SN J1987A -02

J1987A RATS

Updated replacement of analog card for improved PESQ scores

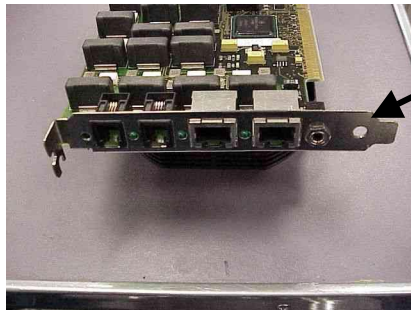
Adapting the Infineon ALIS FXO chipset for use in the E&M ports of the analog board results in extra circuit noise. This limits the maximum PESQ scores. Replacing this board with the modified assembly reduces the circuit noise and improves the possible PESQ scores when using the E&M ports .

Replace the analog FXO E&M card with the latest version. This, along with downloading the VQT application Software Version 4.1.1 or later. When the “defective” analog card is removed the metal grounding tab MUST be swapped to the new assembly.

Move metal tab to
new assembly.
